Access Compliance Report

Public Rights-of-Way

| Intersection ID: 21685 | Main Street: POPLAR_FOREST_DR | Cross Street: WATERFALL_PL | Location: SW |
| ADA ID: 5A6BD42C7347 | Ramp Type: PerpDiag | Initial Pass/Fail: Fail | Overall Compliance: No |

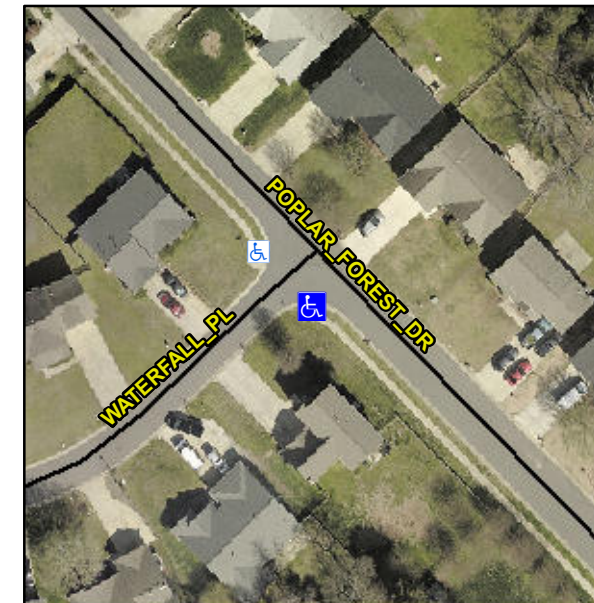
R304.5.1, R304.5.3

| Compliance | Description | Data | Compliance | Description | Data |
|------------|-----------------------|-------|------------|-----------------------------|-------|
| No | Ramp Width (in) | 33.0 | No | Ramp XSlope (%) | 3.7 |

Remove & Replace Curb Ramp With Two New Directional Ramps or Equivalent.
